In the Matter of:	
ELECTRONIC INVESTIGATION OF THE	)
PROPOSED POLE ATTACHMENT TARIFFS OF INVESTOR OWNED ELECTRIC UTILITIES	) CASE NO. 2022-00105

# RESPONSE OF LOUISVILLE GAS AND ELECTRIC COMPANY AND KENTUCKY UTILITIES COMPANY TO KENTUCKY BROADBAND AND CABLE ASSOCIATION'S SUPPLEMENTAL REQUEST FOR INFORMATION DATED MAY 19, 2022

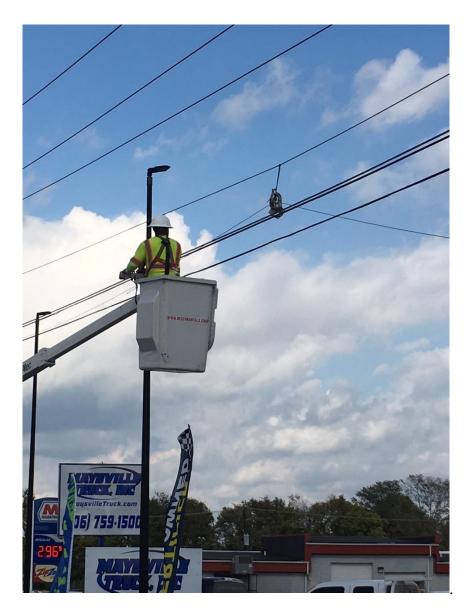
- Q-4. Provide any data related to Your contention that during periods of "high deployment," "[b]y necessity, Attachment Customers often resort to utilizing lower-quality communications contractors, which leads to a higher incidence of defective installations." *See* Response to KBCA RFI 1-7.
- A-4. In the Companies' experience, larger attachment projects result in larger numbers of installation defects—installations that are not performed according to the approved design or that are performed in an unsafe manner—relative to "regular"-sized projects. 132 of the 168 violations noted in the Companies' Response to KBCA's First Request for Information, Item 1, occurred during large attachment projects.

Anecdotally, Company personnel have noted that the construction crews associated with most of the defects are contractors that the Company personnel are not used to seeing on the Companies' system. In an egregious example shown below, one such contractor was directed to stop work because he was using the neutral wire to support his cable roller as he attached fiber to a messenger wire. The individual was unidentified and was working in an unmarked rental truck.
